**FW: Emission Points on Roof**  
Zachary, Aled

Please could we have permission to split emission point 93 (4<sup>th</sup> process jet zone bleed) into two emission points. The majority of the hot air within the Jet zone oven zones is recirculated but a small proportion has to be bled off. The oven has two zones and the intention is to separate the bleed air from these zones so that zone 1 air is vented through the roof to atmosphere. This new duct will only vent hot air only and there will be no increase in noise as the existing zone 1 fan motor will remain in its current location.

**OVEN 1 BLEED DUCTWORK MODIFICATIONS**

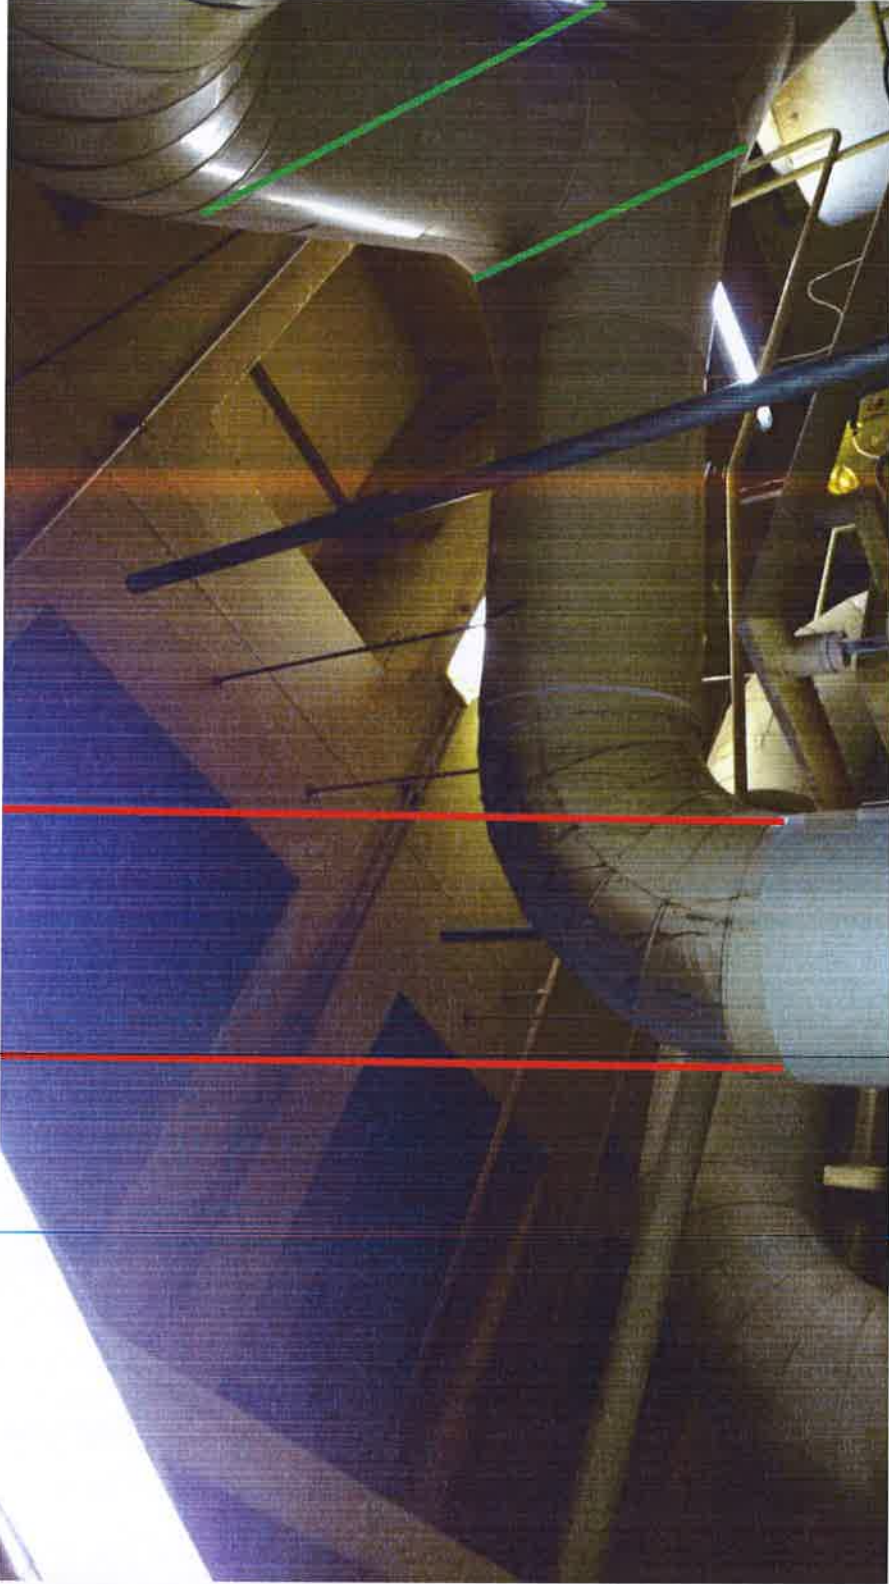
— New Zone 1 Duct through penthouse venting to atmosphere.

— New Transition piece for size change on existing ductwork. Will become zone 2 only to existing cyclone.

New Duct  
through  
penetration  
structure
